AGREEMENT

WHEREAS, the CRA desires to retain the services of the Contractor to provide the goods and services in accordance with the CRA's Invitation to Bid No. 2022-01-R, and the Contractor's response thereto, all of which are incorporated herein by reference.

ARTICLE 1. INCORPORATION OF INVITATION TO BID

A-621

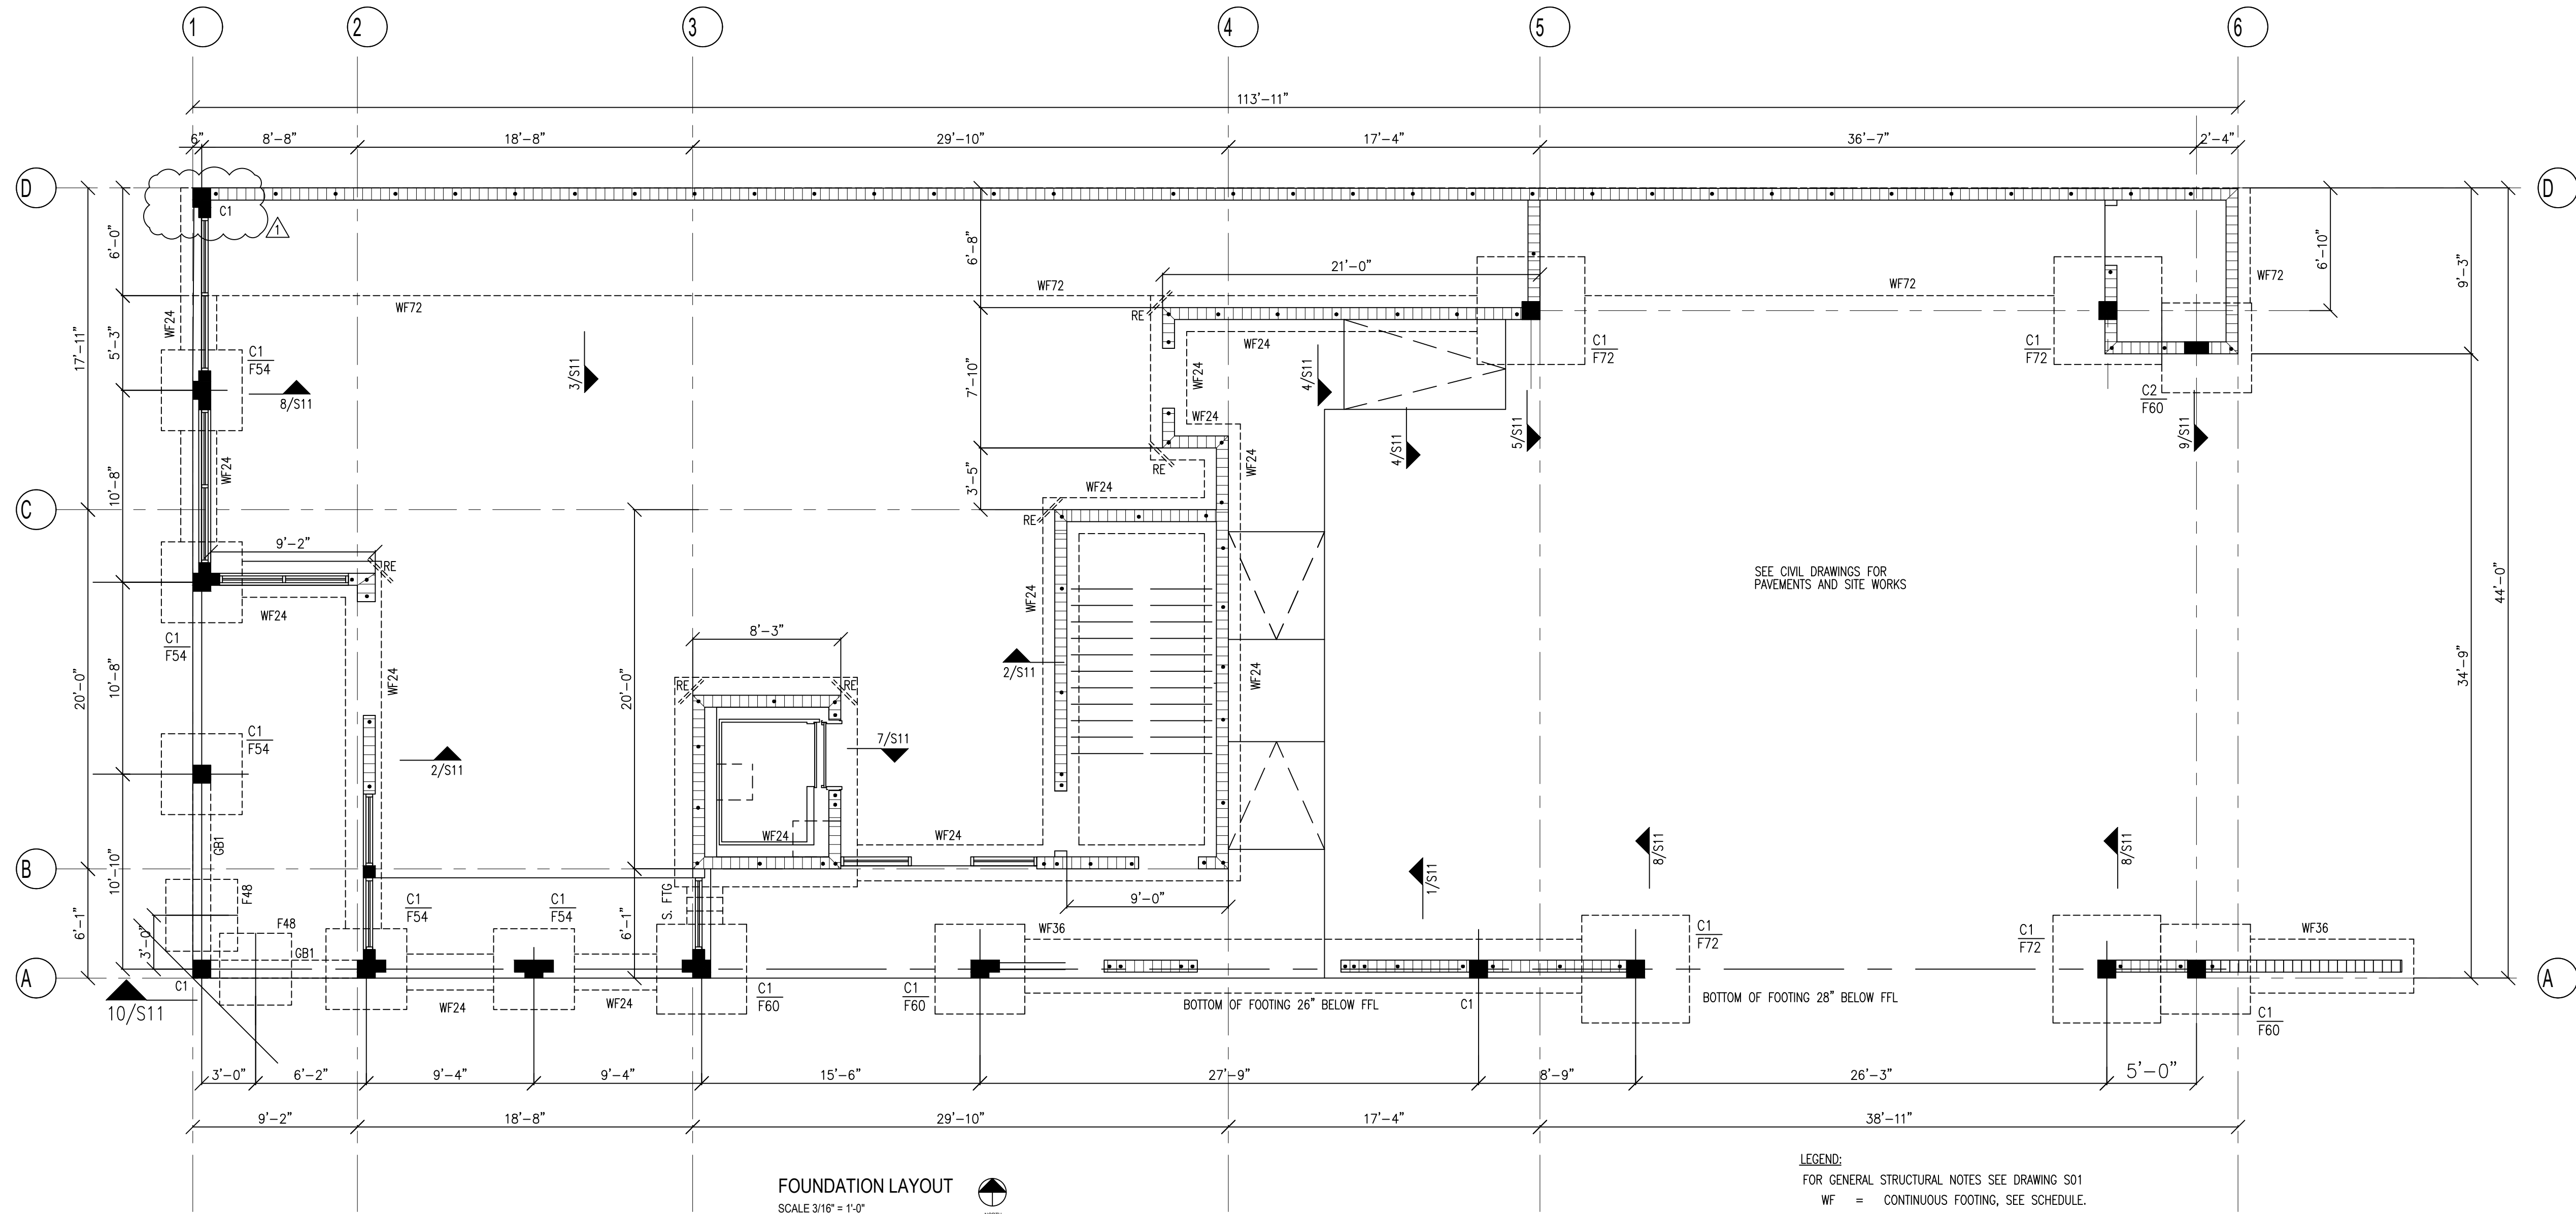
13. **Sheet A-621 is missing from the ITB documents. Please provide missing sheet.**

Sheet A-621 is attached to this Addendum.

S10

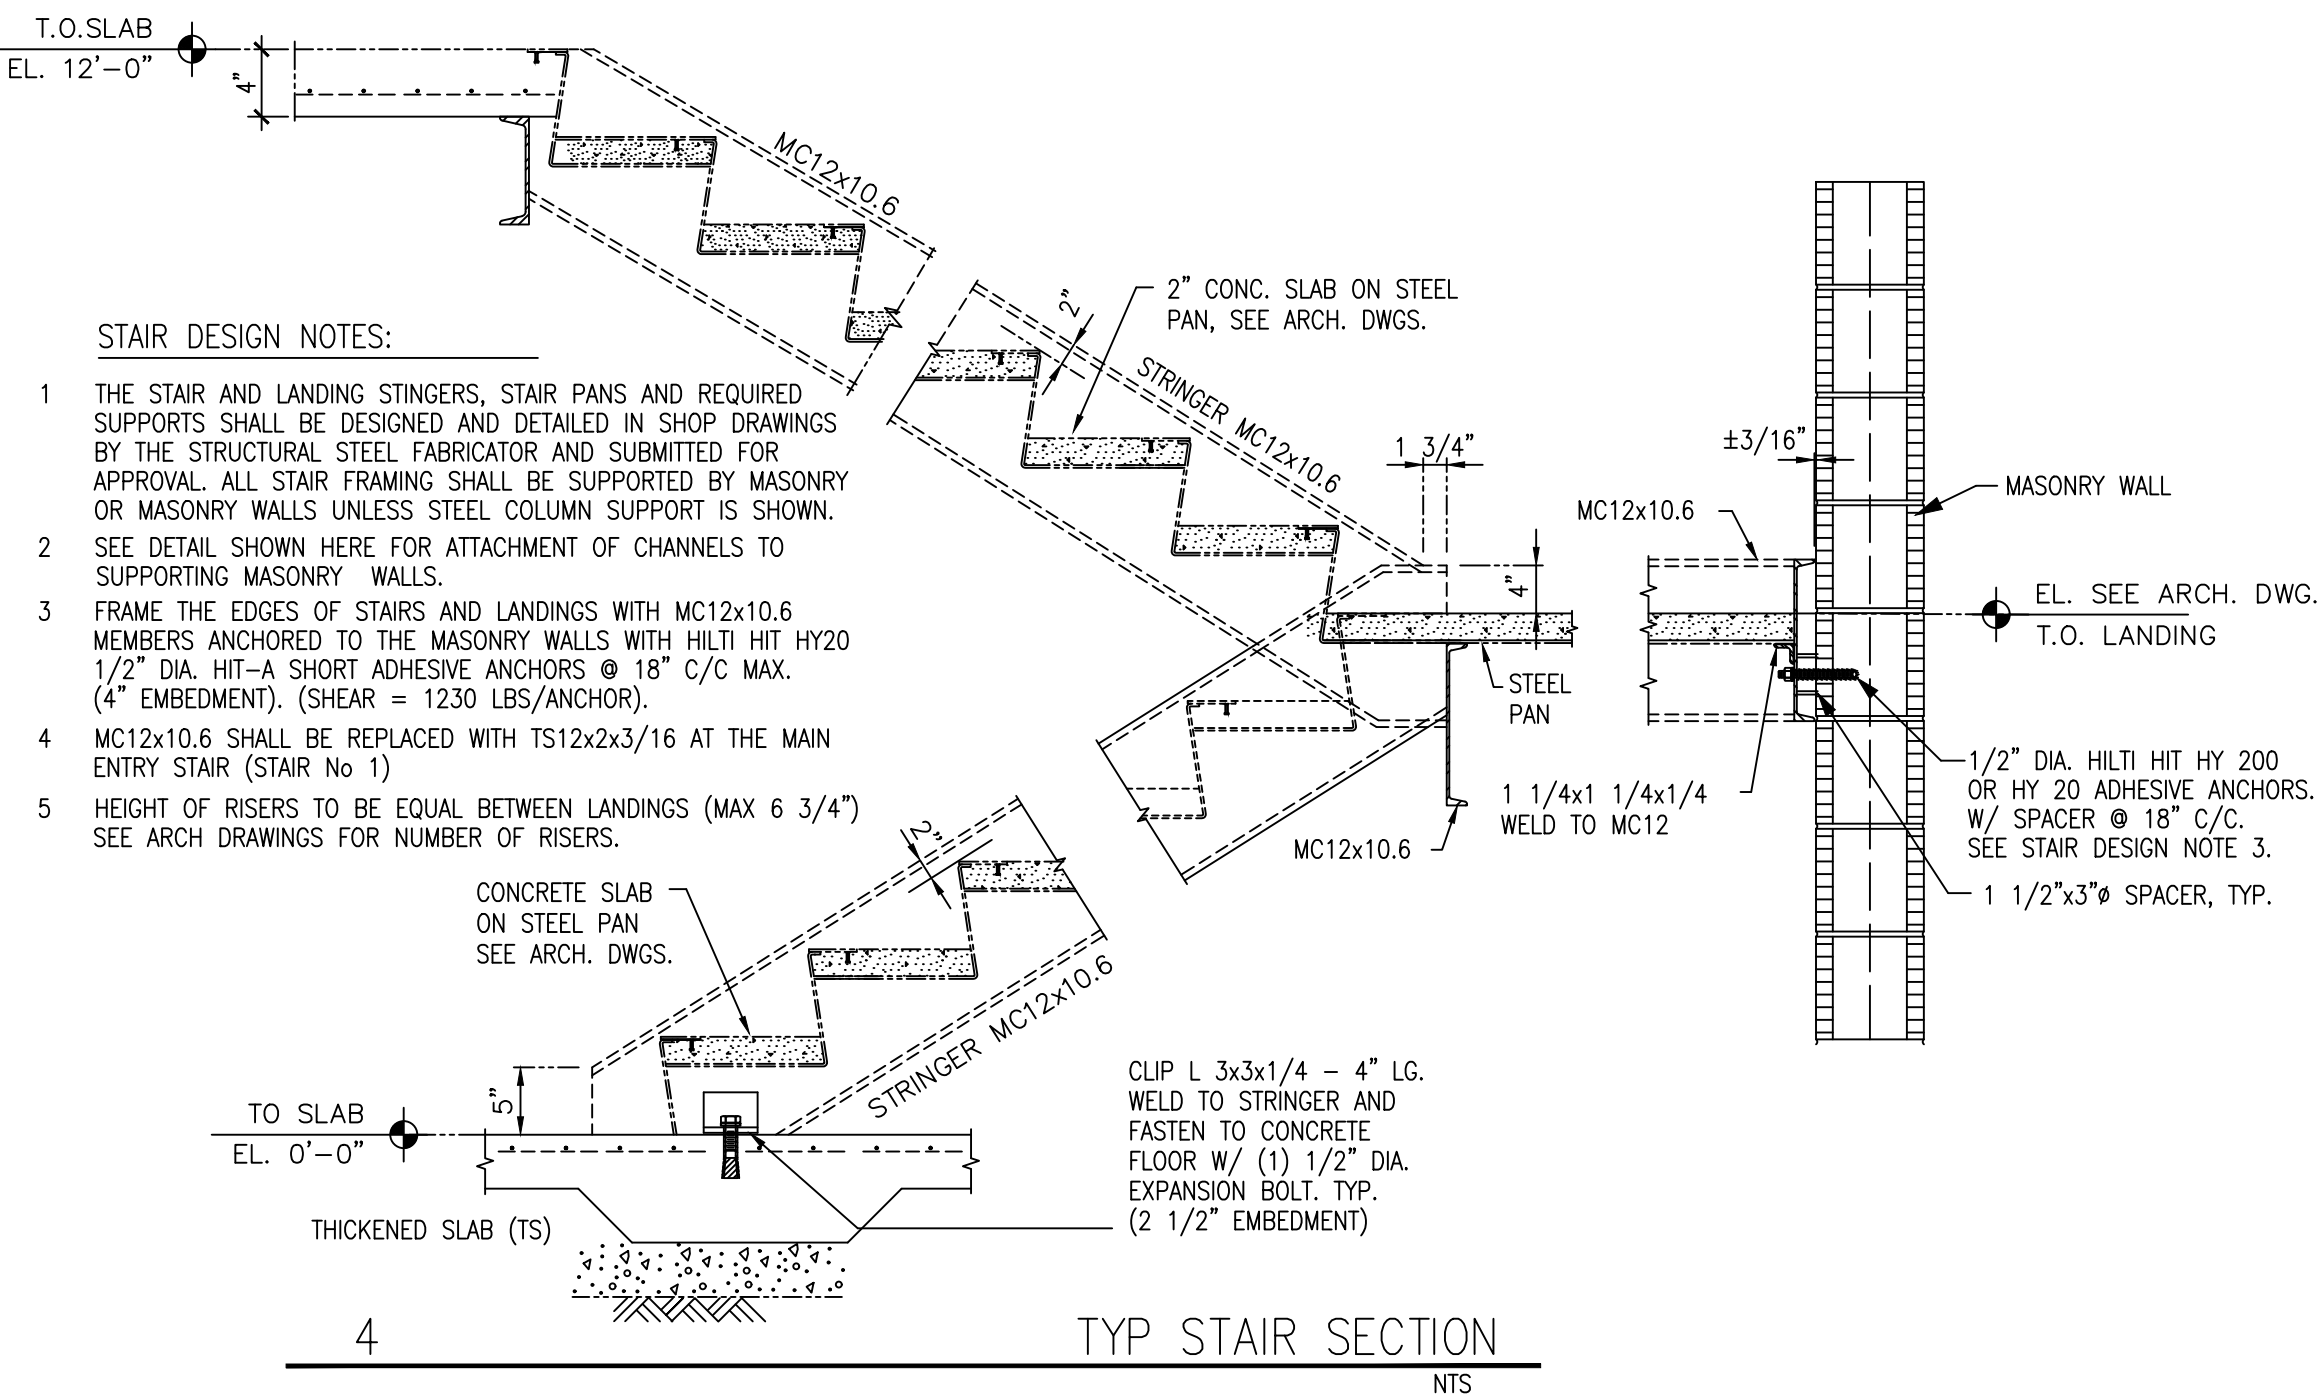
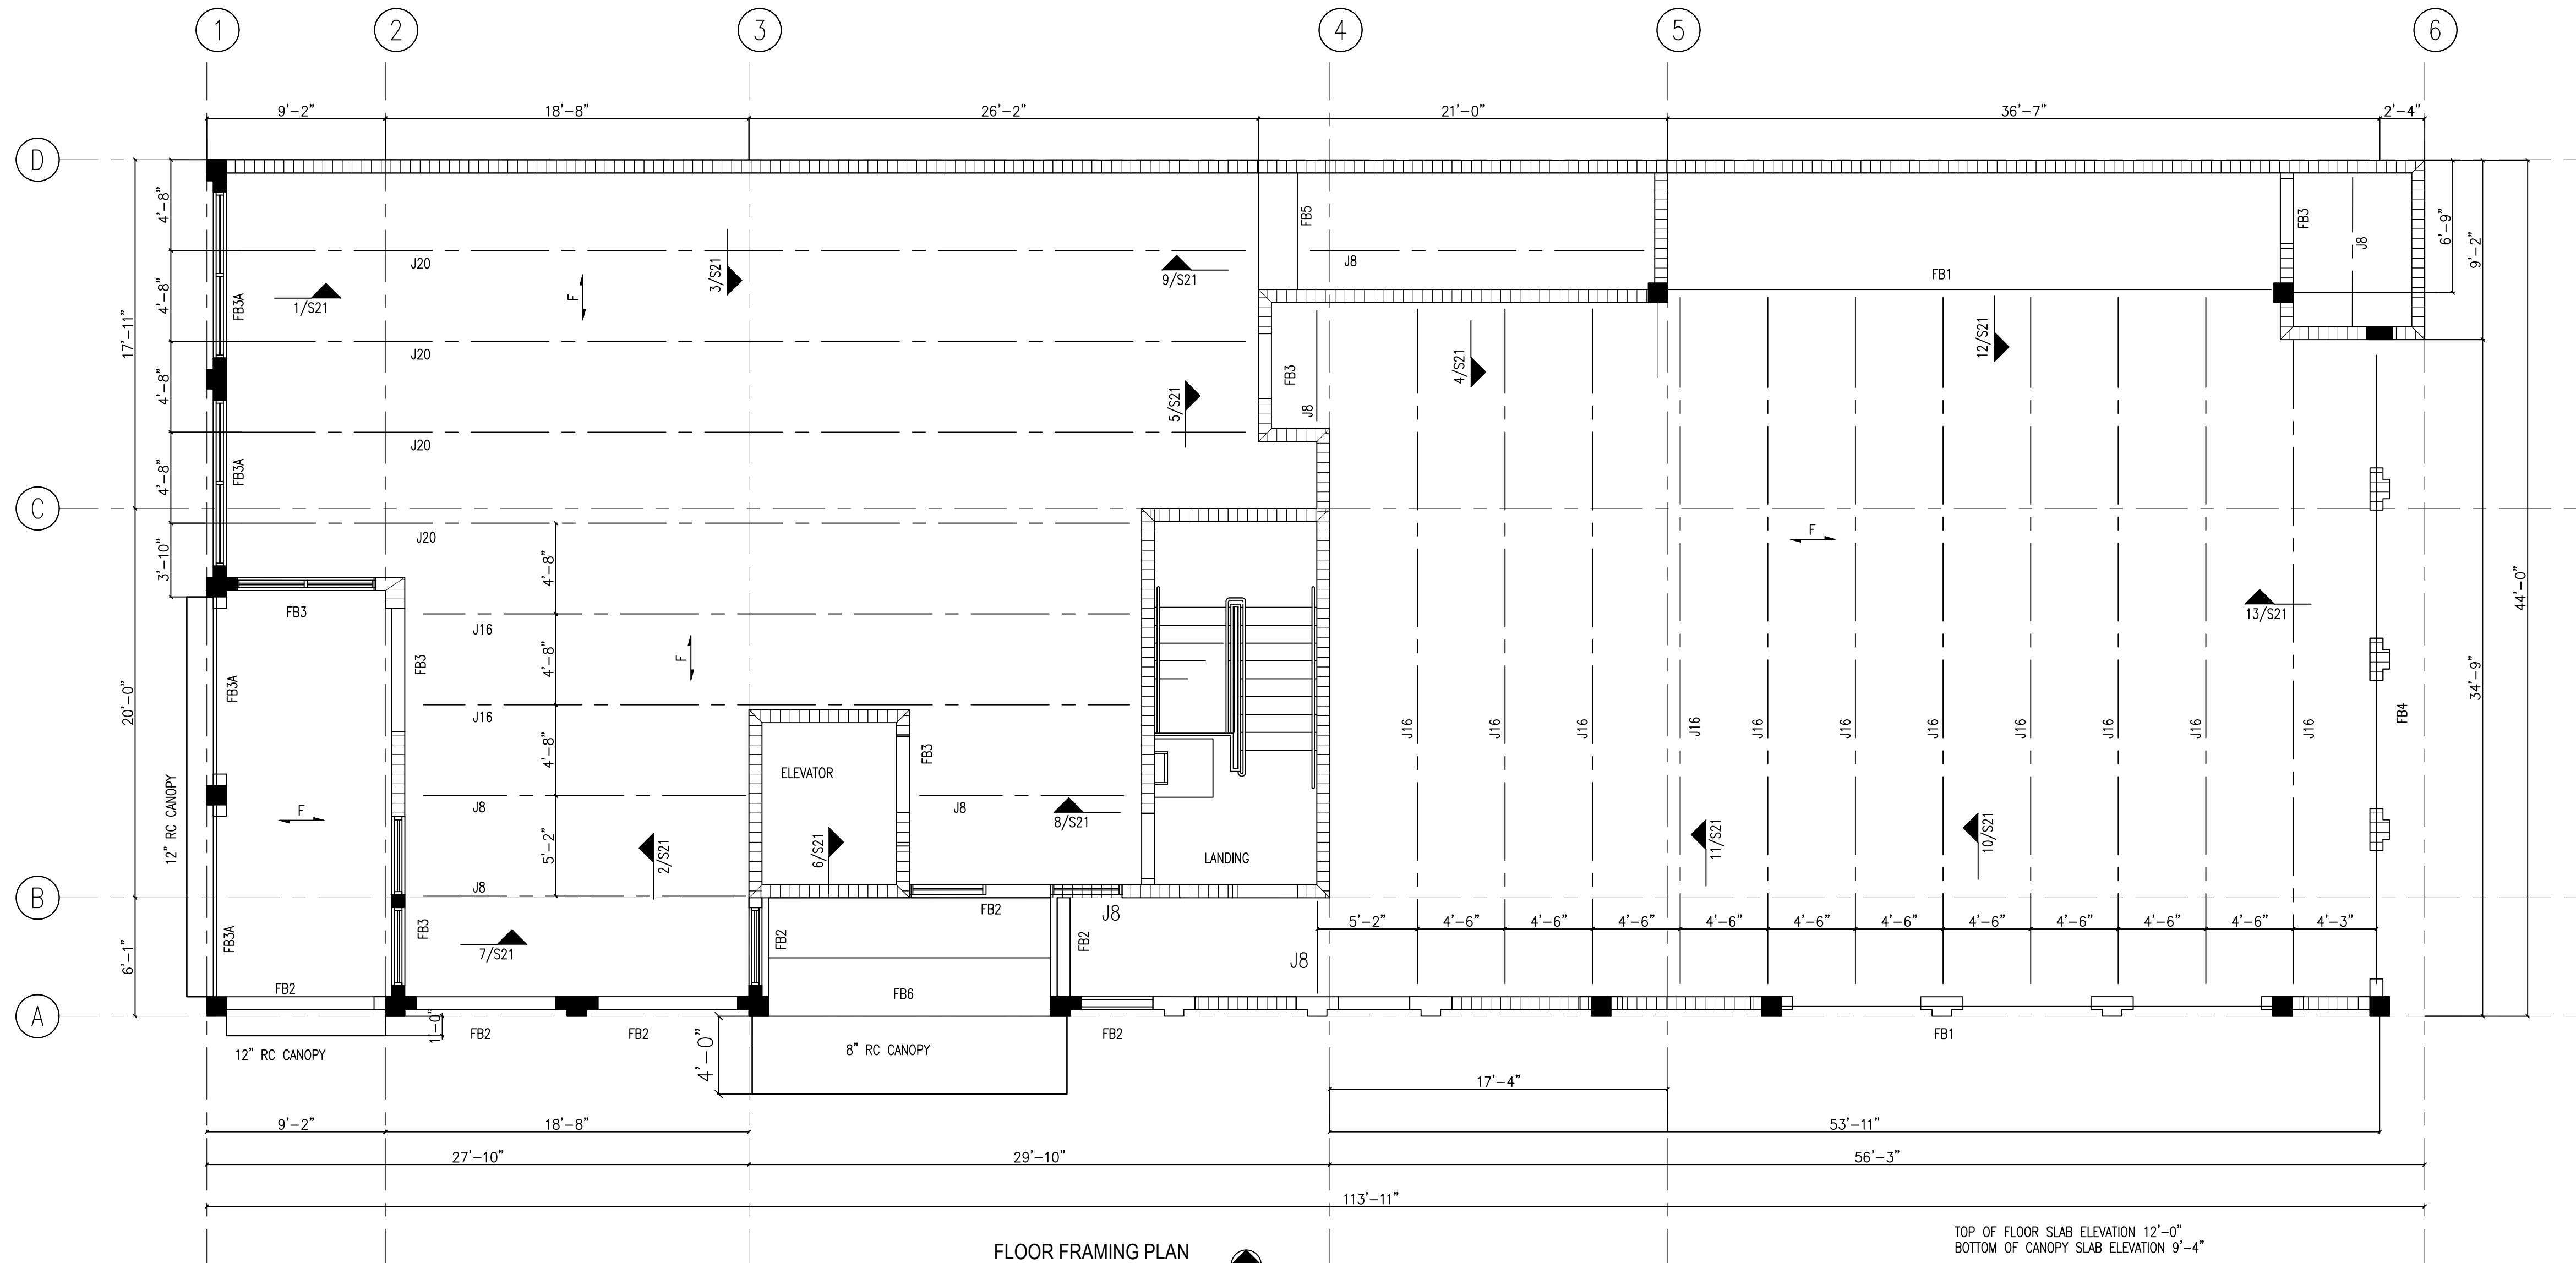
18. **F36 shows on the spread footing schedule, but it is not show on the floor plan (Drawing S10), please clarify.**

19. **C1 square appearance on the floor plan does not match with the square appearance of the column schedule (Drawing S10) , please clarify.**

20. **Two columns do not have marks (Drawing S10). Please clarify.**

F36 not used in the project. Drawing S10 is attached to this Addendum.

C1 is a square column sometimes with poured wall attached. Drawing S10 is attached to this Addendum.

C1 at grid line 1D, wall at grid line 2B. Drawing S10 is attached to this Addendum.
